# UNITED STATES PATENT AND TRADEMARK OFFICE

APPLICATION NO.	FILING DATE	FIRST NAMED INVENTOR	ATTORNEY DOCKET NO.	CONFIRMATION NO.
10/656,222	09/08/2003	Morton M. Mower	302527US78	1067
22850 7590 09/26/2007 OBLON, SPIVAK, MCCLELLAND MAIER & NEUSTADT, P.C. 1940 DUKE STREET ALEXANDRIA, VA 22314				
			EXAMINER KAHELIN, MICHAEL WILLIAM	
			ART UNIT 3762	PAPER NUMBER
			NOTIFICATION DATE 09/26/2007	DELIVERY MODE ELECTRONIC

## Office Action Summary

## DETAILED ACTION

**FIG. 1**

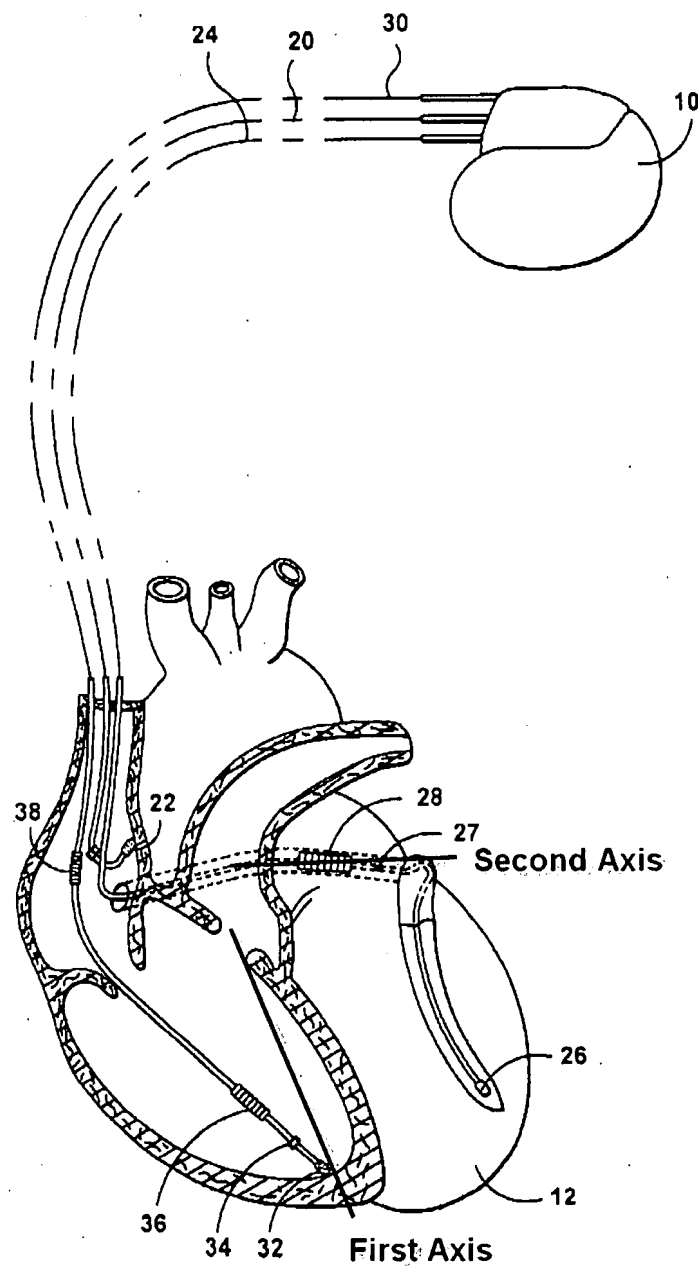
5. In regards to claims 1 and 67, Levine discloses a method/device for monitoring hemodynamic performance comprising positioning signaling electrodes along a first and second axis (see below), receiving electrical signals indicative of hemodynamic performance (abstract), and delivering stimulation in response to the signals in response to commands from a processor (60). Please note that the claims do not require multiple electrodes on either of the two axes. Further, based on the common usage of the term, and comments made during the interview of 9/1/2007, an "axis" does not require structure, but is merely an imaginary line. As such, an arbitrary axis can be applied to a single electrode that meets the claim limitations, and is shown in the figure below.

6. In regards to claims 2 and 68, signals are received from the atrium (22, 82, 204, and 216).

7. In regards to claims 3 and 69, signals are received from the left ventricle (25-29).
8. In regards to claims 20 and 70, the electrodes are placed endocardially (Figs. 1 and 3).
9. In regards to claims 27 and 71, the electrodes are placed in a coronary vein (25-29).
10. In regards to claim 28, a signaling electrode is on a lead passing through the SVC, the right atrium, ostium of the coronary sinus, and a coronary vein (21 and 24).
11. In regards to claims 65 and 73, one of the plurality of electrodes is located within the entrance of the coronary sinus along the first axis (21 and 24).
